**Subject: Wambo Coal Mine – Approval of Extraction Plan for Longwalls 24 to 26**

Department’s Consideration of the Longwall 24 to 26 Extraction Plan

Table 2 | Department’s Review Comments for Wambo Extraction Plan - Longwalls 24 to 26

Figure 1 | Longwall 24 to 26 Extraction Plan Area

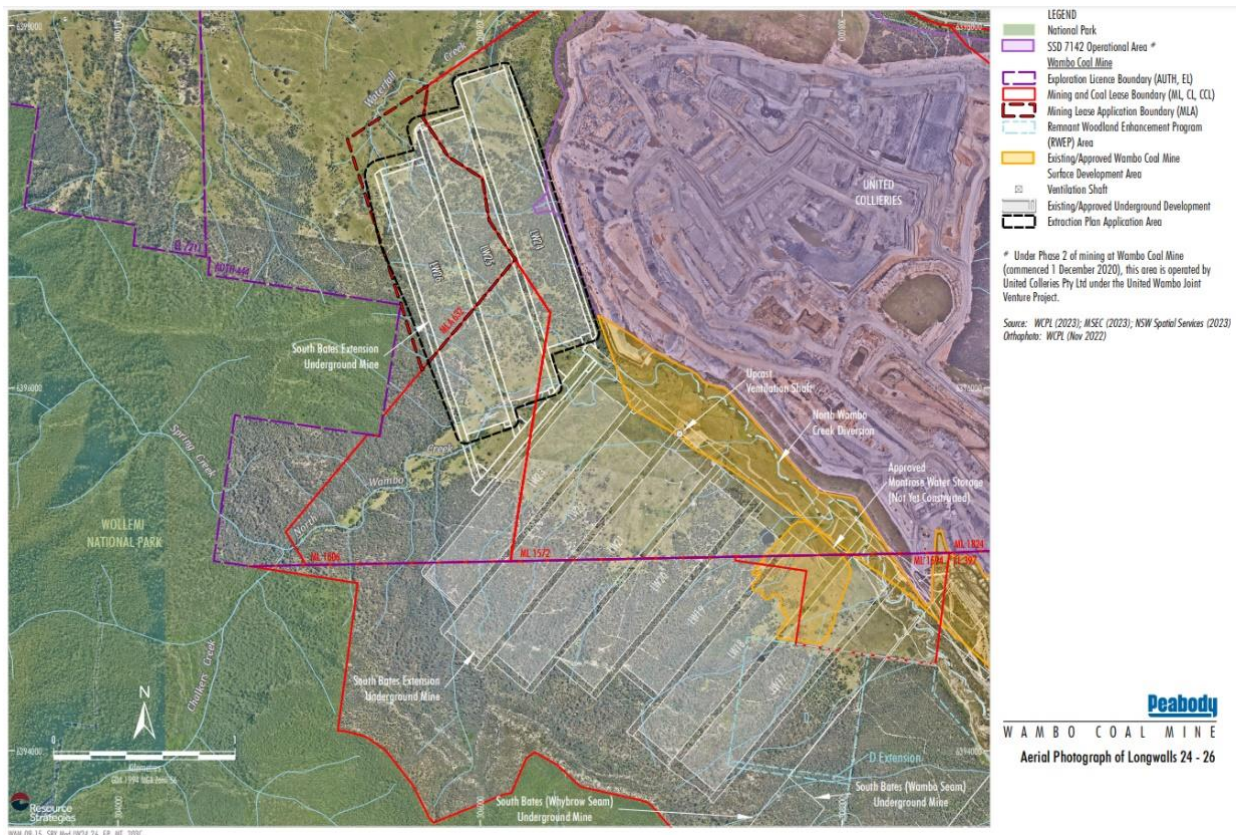
Since modification 19 was approved in January 2023, the Department acknowledges that there has been a minor amendment to the length of Longwall 24 (reduced by approximately 39 meters at the southern end), which has been reflected in the revised Extraction Plan. The Department considers that the shortening of Longwall 24 would result in similar or less subsidence related impacts compared to that presented in modification 19.

Since modification 19 was approved in January 2023, the southern end of Longwall 24 has been reduced by approximately 39 meters, which has been reflected in the revised Extraction Plan. The Subsidence Assessment titled ‘South Bates Extension Underground Mine Longwalls 24 to 26 Extraction Plan’ prepared by Mine Subsidence Engineering Consultants (Report 1 of the Extraction Plan), incorporates the revised layout and concluded that the maximum predicted subsidence effects are the same as, or slightly less than, those presented in the modification 19 modification report titled ‘Wambo Coal Mine Longwall 24 to 26 Modification’ dated August 2022.

Accordingly, the Department considers that the shortening of Longwall 24 would result in similar or less subsidence related impacts compared to the currently approved impacts.
